CONSTRUCTION DOCUMENTS GRADING & EROSION CONTROL PLAN

CBP, F2-LOT #8

1415 SELIX GROVE, COLORADO SPRINGS, CO

PCD PROJECT NO. PPR-17-046

PROPOSED SIDEWALK CROSS SECTION

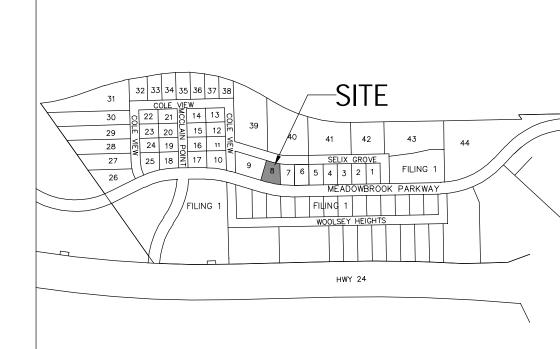
Revise. Per standar cross section offset sidewalk 6" from 4" THICK EXISTING ROW SIDEWALK EXISTING CURB AND GUTTER LANDSCAPE PROPOSED CURB AND GUTTER

Revise. Per standard cross section offset sidewalk

6" from ROW.
